Access Compliance Report

Public Rights-of-Way

(Curb Ramps)

Intersection ID: 53704	Main Street: MILLSTREAM RIDGE DR	Cross Street: CHRISTENBURY RD	Location: S
ADA ID: 9DE9DEB44D21	Ramp Type: BlendTrans1	Initial Pass/Fail: Pass	Overall Compliance: No
Severity Score: 20			
Codes/Mitigation Info/Possible Solution		Field Measurements/Component Compliance

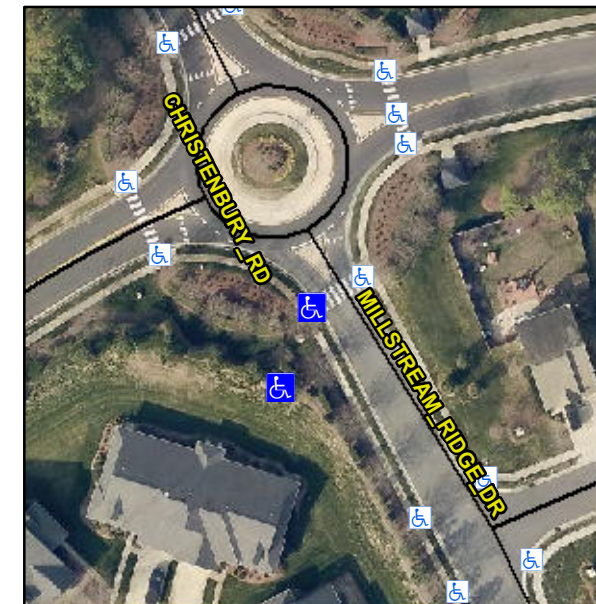
LNDG LIP 1.0

Not Found, R304.2.1, R304.2.2-Perp, R304.3.2-Para, R302.7.2, R304.5.4

Compliance	Description	Data	Compliance	Description	Data
N/A	Ramp Length (in)	51.0	Yes	BlendTrans Slope (%)	1.1
Yes	Ramp Width (in)	49.0	Yes	BlendTrans XSlope (%)	1.6
N/A	Flare Type LT	Sloped	N/A	Flare Type RT	Sloped
N/A	Flare Slope LT (%)	1.0	N/A	Flare Slope RT (%)	3.9
N/A	Flare Traversable LT?	No	N/A	Flare Traversable RT?	No
No	Landing Length (in)	47.0	Yes	DWS Provided?	Yes
Yes	Landing Width (in)	49.5	Yes	DWS Contrast?	Yes
No	Landing Slope (%)	4.0	Yes	DWS Length (in)	24.0
Yes	Landing X Slope (%)	0.7	Yes	DWS Full Width?	Yes
N/A	Landing Curb? (Y/N)	No	Yes	DWS Offset (in)	2.0
N/A	Shared Landing?	No			
Yes	Gutter Ponding?	No	No	Gutter Slope (%)	5.1
No	Gutter Lip Ht (in)	1.0	Yes	Gutter X Slope (%)	0.0
N/A	Painted X Walk1?	Yes	N/A	Painted X Walk2?	N/A
	X Walk 1 Direction	To E		X Walk 2 Direction	N/A
	X Walk 1 Width (in)	118.0		X Walk 2 Width (in)	N/A
	X Walk 1 Slope (%)	3.2		X Walk 2 Slope (%)	N/A
	X Walk 1 X Slope (%)	1.5		X Walk 2 X Slope (%)	N/A

Yes	Ramp inside XWalk1?	Yes	N/A	Ramp inside XWalk2?	N/A
	Road Slope (%)	1.5		Clear Space?	Yes
	Road X Slope (%)	3.2	N/A	Clear Space to XWalk (in)	N/A
Yes	Any Obstructions?	No	Yes	Storm Grate/Utility Hazard?	No
	Obstruction Type			Storm Grate/Utility Type	
		N/A			N/A
			Yes	Surface Condition? (G/P)	Good
			No	Curb Slope (%)	18.9

Remove & Replace Curb Ramp With Two New Directional Ramps or Equivalent. Remove & Replace Gutter.
